FORD E40D "UPDATE HANDBOOK"

INTRODUCTION FORD E4OD "UPDATE HANDBOOK"

**FORD E40D
VALVE BODY, SPACER PLATE, SPACER PLATE GASKETS,
CHECKBALL LOCATIONS, AND CASE CHANGES,
FOR THE 1996 MODEL YEAR**

Figure 13

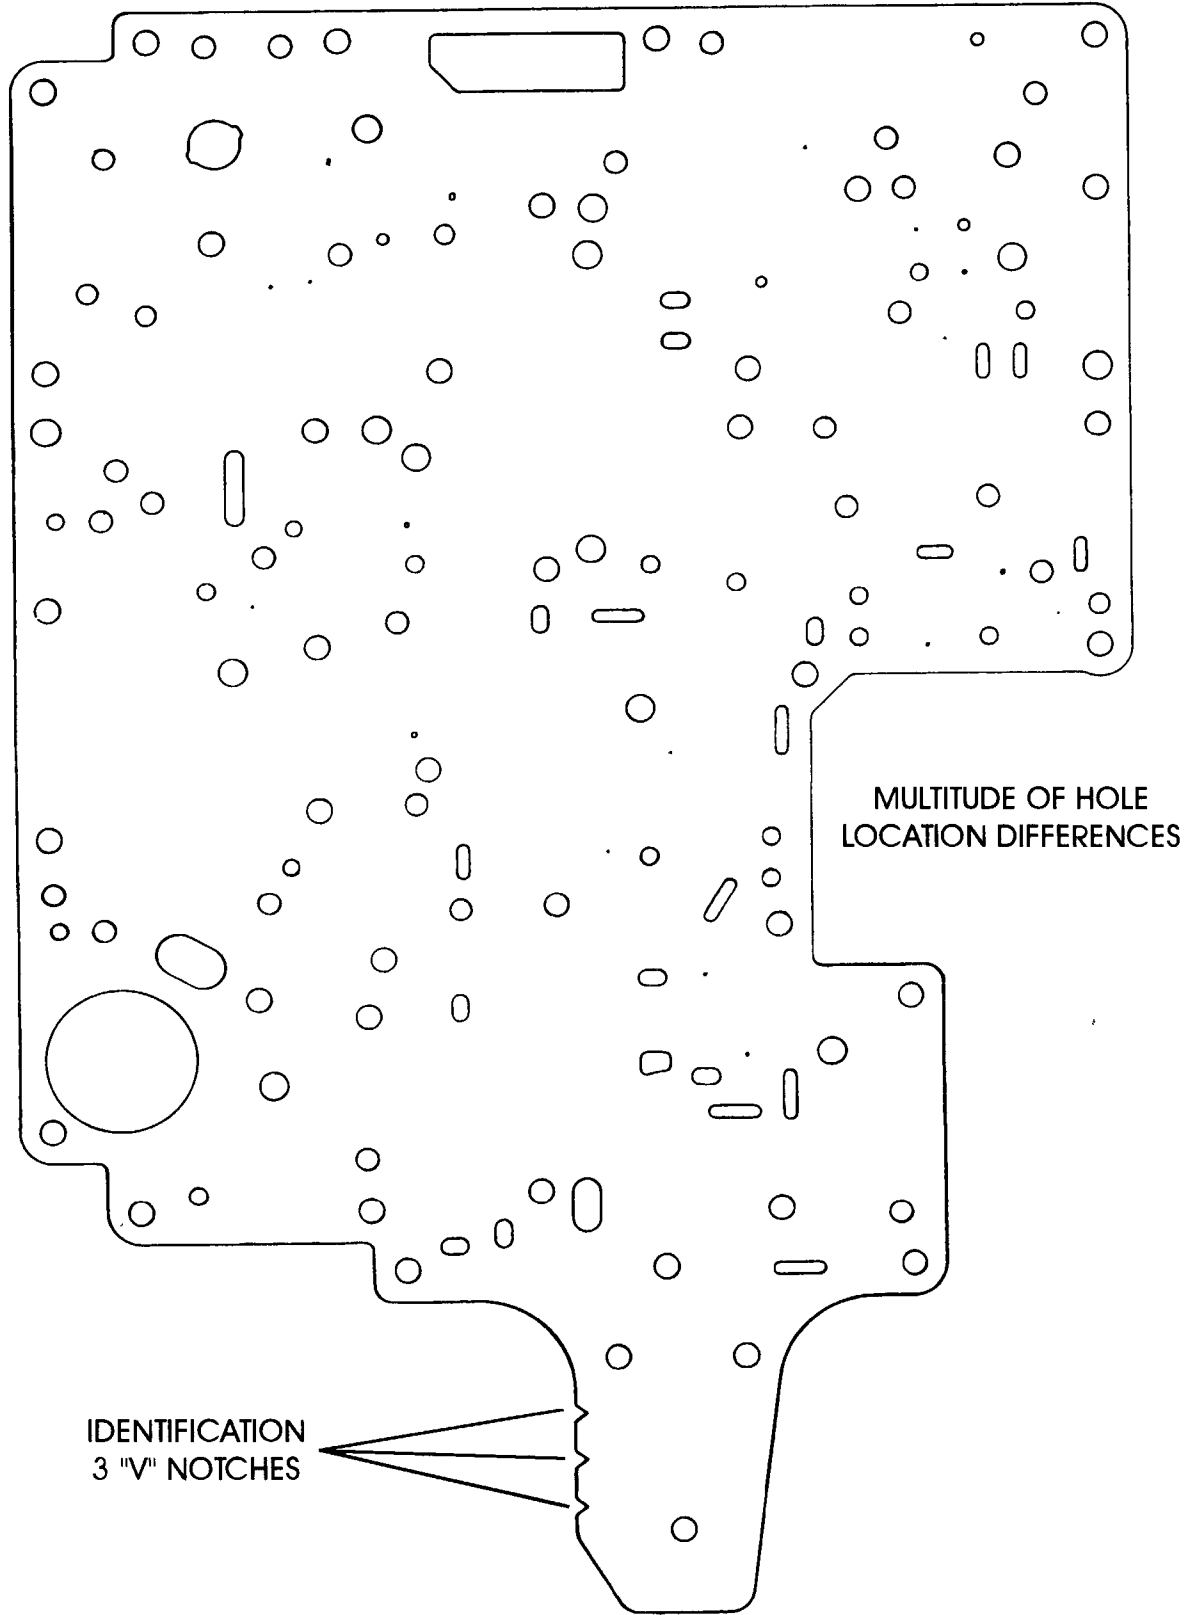
1996-UP Models Only - Requires the Spacer Plate with the three "V" notches for identification as shown in Figure 13, and has a multitude of hole location changes.

Figure 15

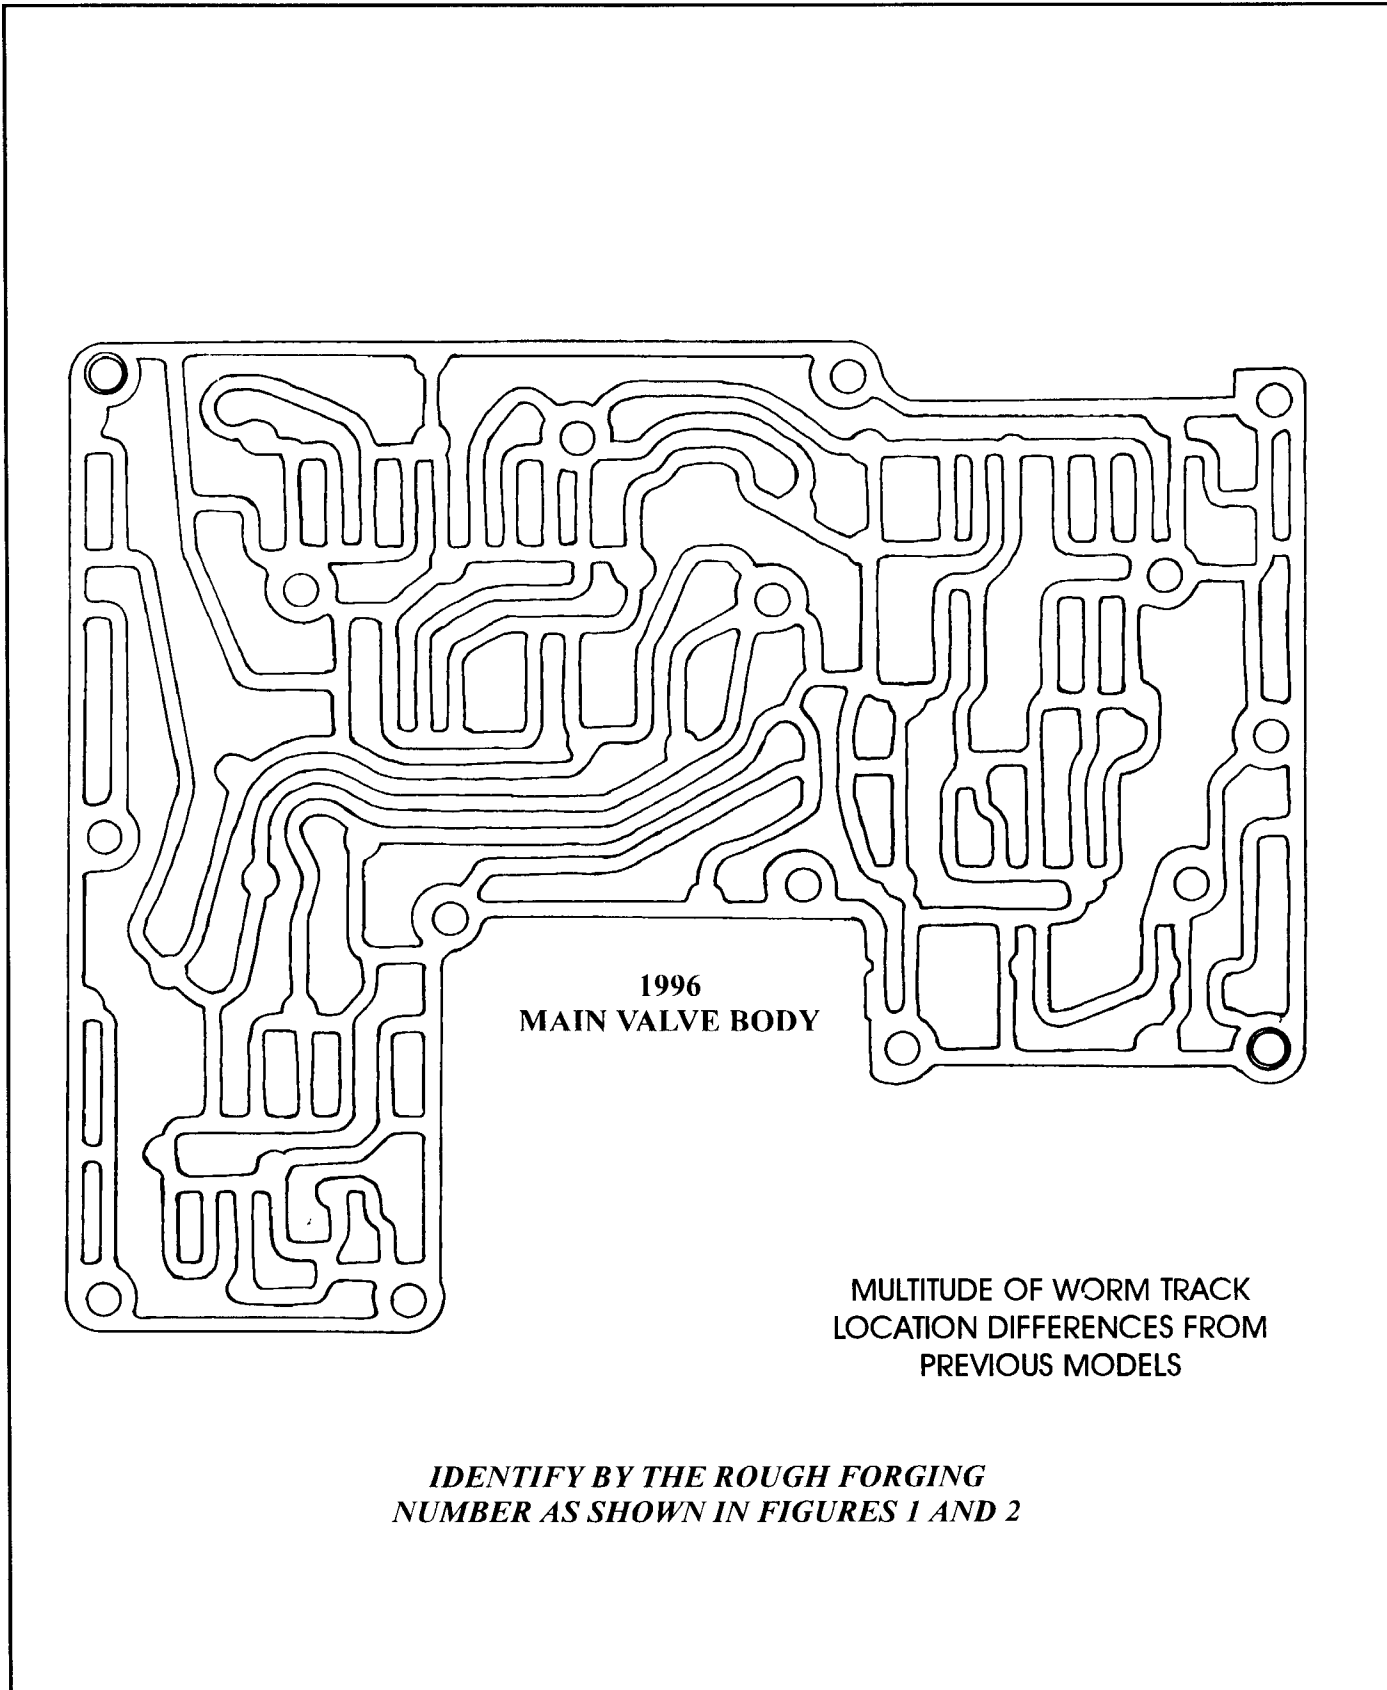
1996-UP Models Only - Has a multitude of worm track location differences from the previous models, as shown in Figure 15. The best and most accurate method to identify the valve body, is the rough forging number cast into the valve body in location shown in Figures 1 and 2.

Figure 16

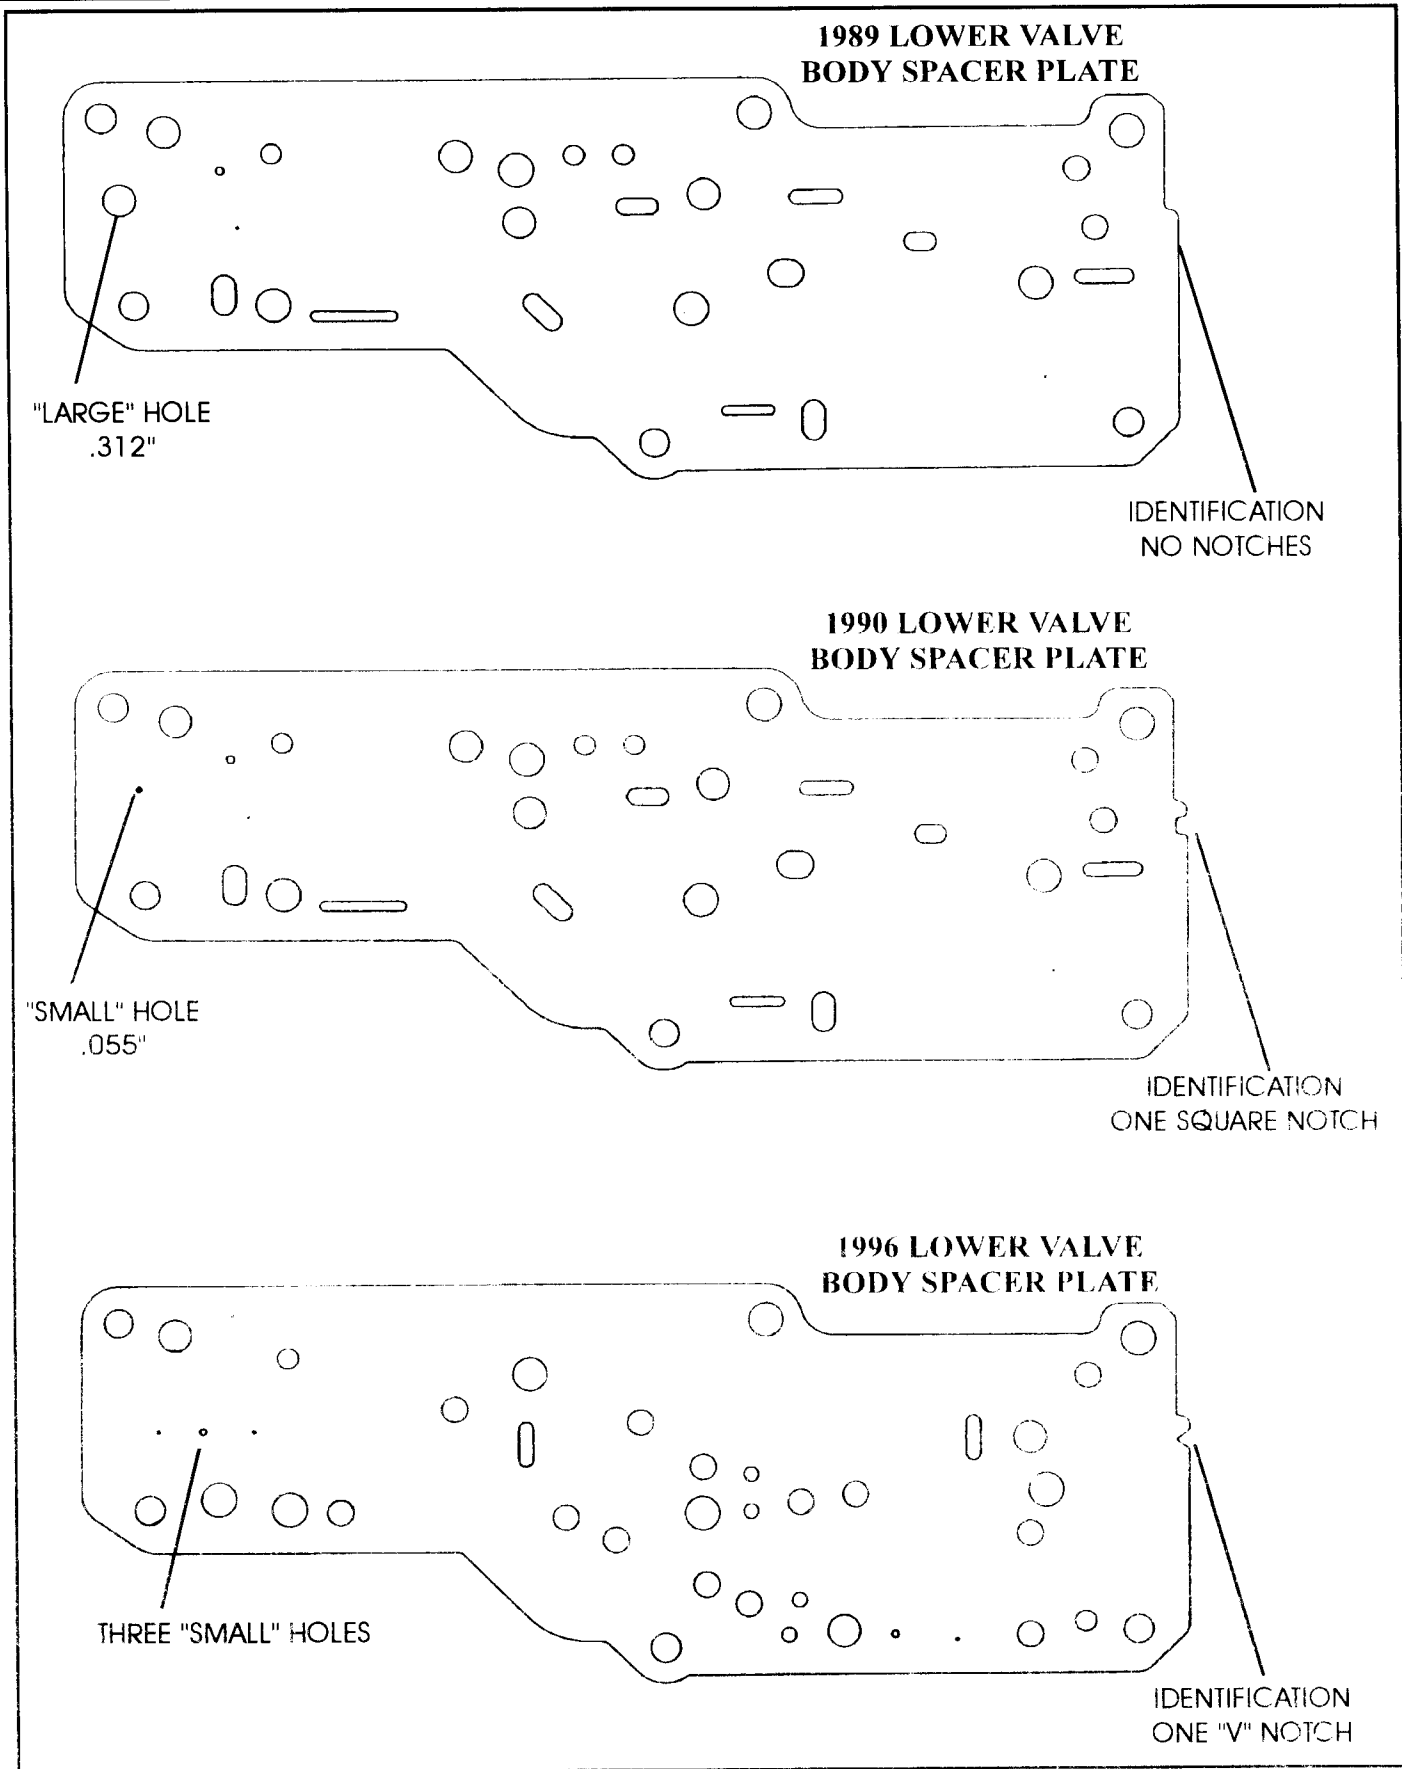
- (6) **LOWER VALVE BODY SPACER PLATE** - Can be identified by the diameter of the feed hole in the location shown in Figure 16. For 1989 models the hole diameter is .312", and for 90-95 models the hole diameter is .055".
The 1996-Up models have three small holes in this location, as shown in Figure 16, and a multitude of hole location differences to accommodate the added valve body checkballs.

Figure 22

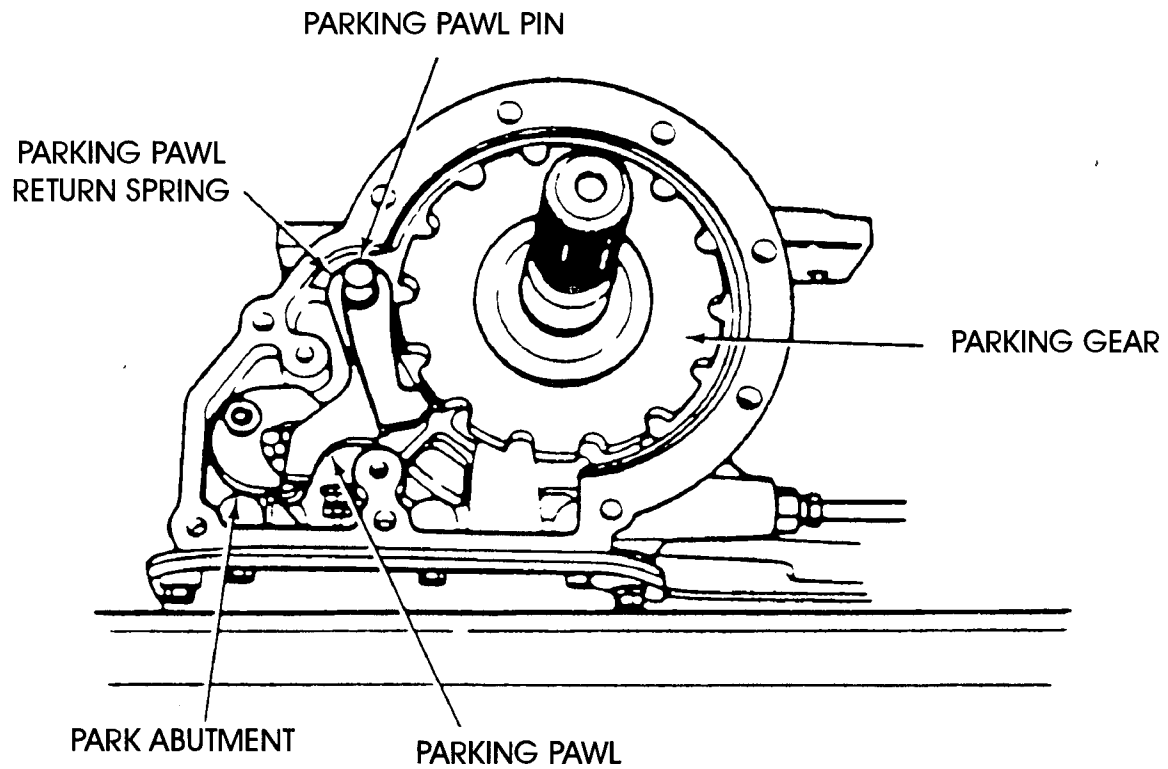
CAUSE: The cause may be a broken snap ring on the output shaft, allowing the parking gear to move rearward, and then the parking pawl cannot engage into the parking gear. Refer to Figure 22.

CORRECTION: There is now available a new service package, under OEM part number F0TZ-7A040-A, that includes a new design extension housing with a new "Boss" cast into it to prevent the parking gear from moving rearward in case the snap ring breaks (See Figure 24). The service package also includes a new "*high strength*" snap ring, and a snap ring installation aid, as shown in Figure 25.

Figure 26

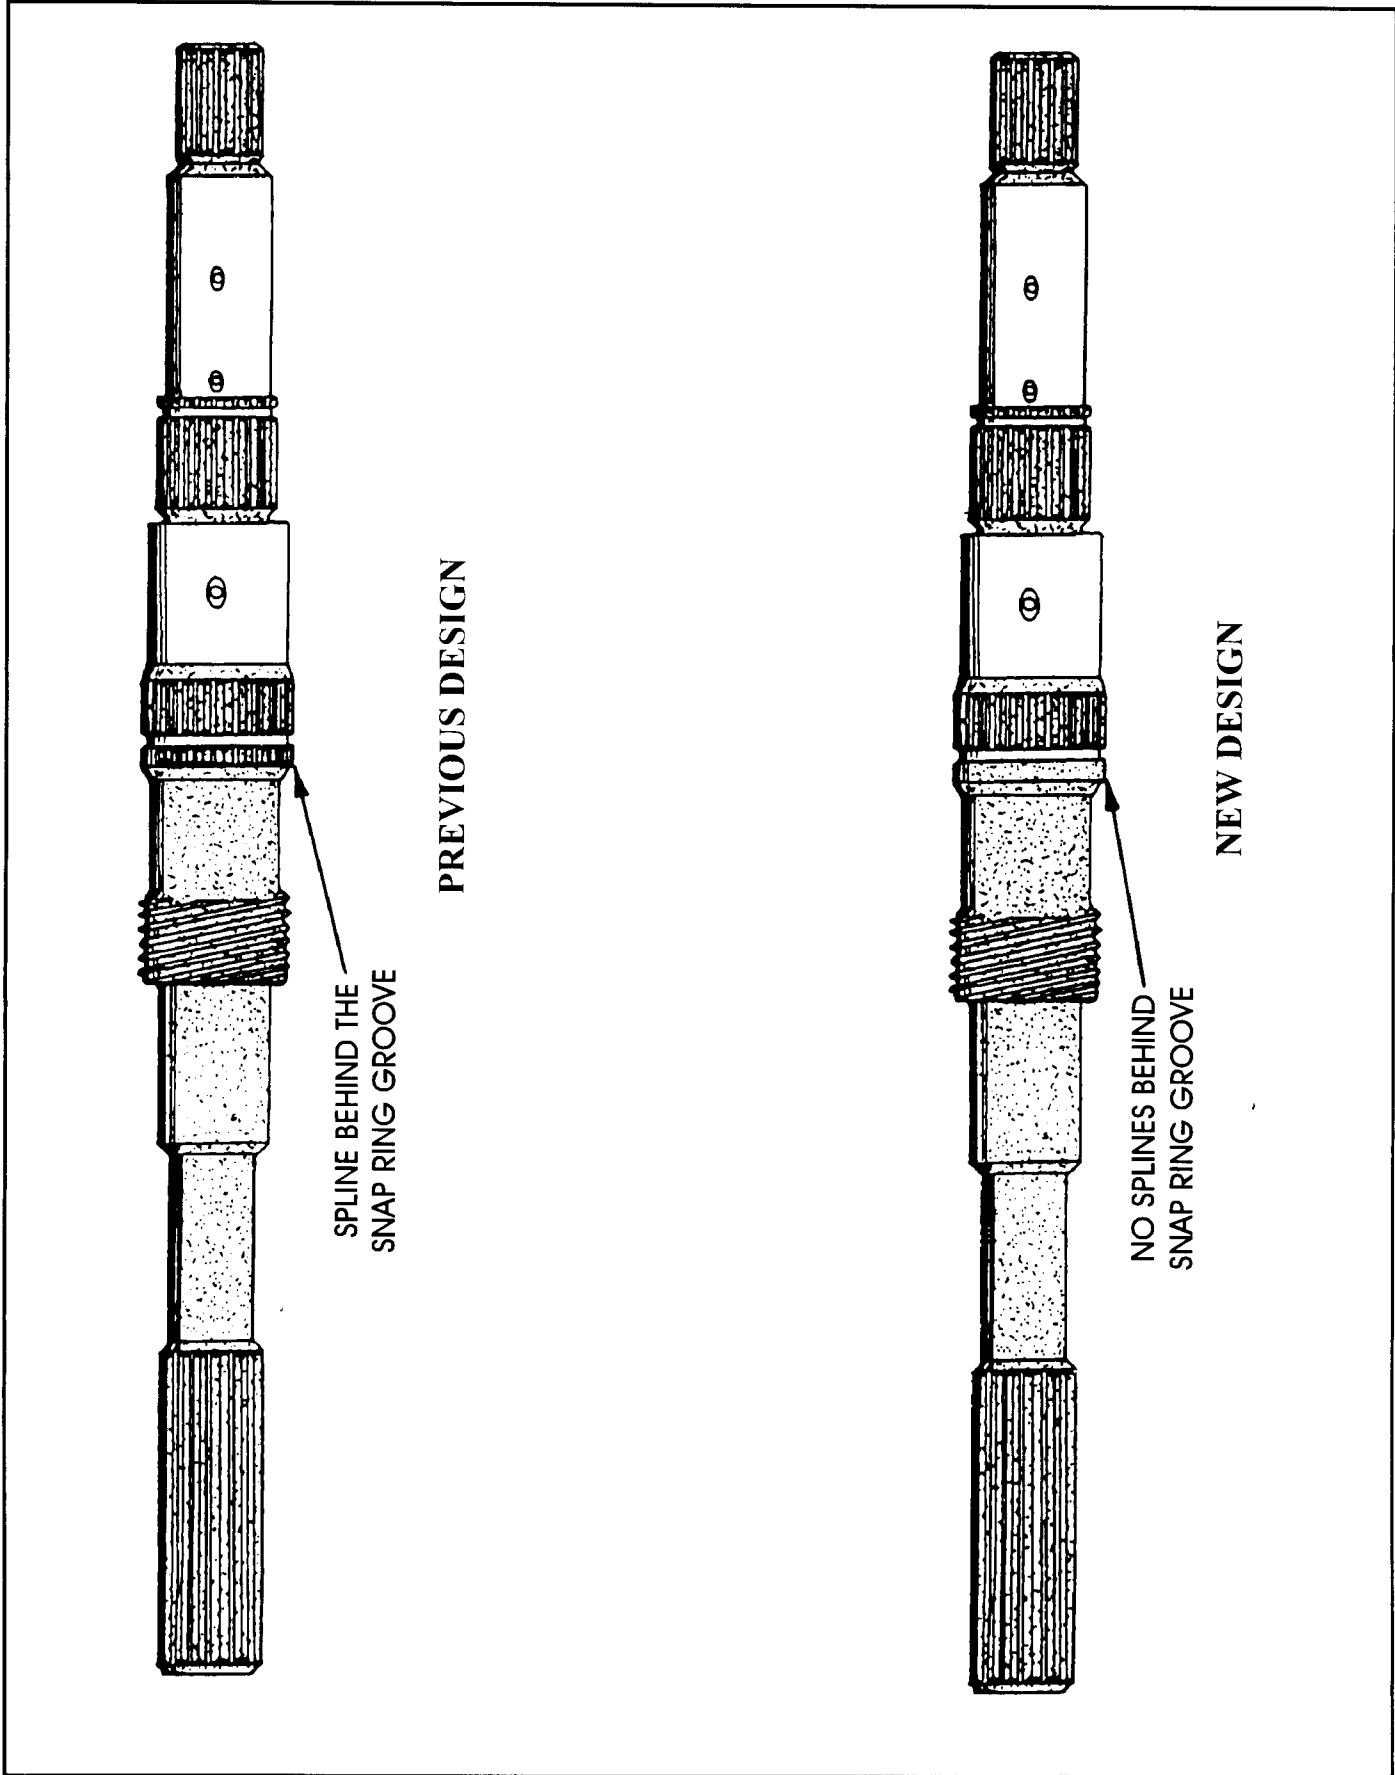
The Output Shaft has also been redesigned for 1990 and later models, with the splines removed from behind the parking gear snap ring groove, which creates an increased shoulder for the snap ring, and helps prevent the snap ring from breaking. Refer to Figure 26.
